# Access Compliance Report

## Public Rights-of-Way

Intersection ID: 10020375		Main Street: BALLANTYNE CORPORATE PCross Street: N/A		Location: NE					
ADA ID: 911966D016C5		Ramp Type: Perp		Initial Pass/Fail: Fail		Overall Compliance: No		Severity Score: 1.25	
Codes/Mitigation Info/Possible Solution					Field Measurements/Component Compliance

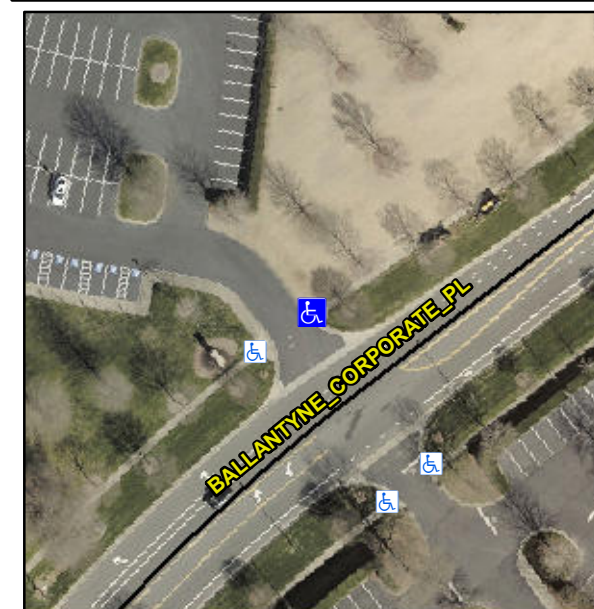
Compliance	Description	Data	Compliance	Description	Data
N/A	Ramp Length (in)	102.0	Yes	Ramp Slope (%)	6.7
Yes	Ramp Width (in)	48.0	No	Ramp XSlope (%)	3.1
N/A	Flare Type LT	N/A	N/A	Flare Type RT	N/A
N/A	Flare Slope LT (%)	N/A	N/A	Flare Slope RT (%)	N/A
N/A	Flare Traversable LT?	N/A	N/A	Flare Traversable RT?	N/A
N/A	Landing Length (in)	N/A	N/A	DWS Provided?	N/A
N/A	Landing Width (in)	N/A	N/A	DWS Contrast?	N/A
N/A	Landing Slope (%)	N/A	N/A	DWS Length (in)	N/A
N/A	Landing X Slope (%)	N/A	N/A	DWS Full Width?	N/A
N/A	Landing Curb? (Y/N)	N/A	N/A	DWS Offset (in)	N/A
N/A	Shared Landing?	N/A			
N/A	Gutter Ponding?	N/A	N/A	Gutter Slope (%)	N/A
N/A	Gutter Lip Ht (in)	N/A	N/A	Gutter X Slope (%)	N/A
N/A	Painted X Walk1?	No	N/A	Painted X Walk2?	N/A
	X Walk 1 Direction	To SW		X Walk 2 Direction	N/A
N/A	X Walk 1 Width (in)	N/A	N/A	X Walk 2 Width (in)	N/A
	X Walk 1 Slope (%)	3.3		X Walk 2 Slope (%)	N/A
	X Walk 1 X Slope (%)	1.1		X Walk 2 X Slope (%)	N/A

**Remove & Replace Entire Ramp.**

**R304.5.3**
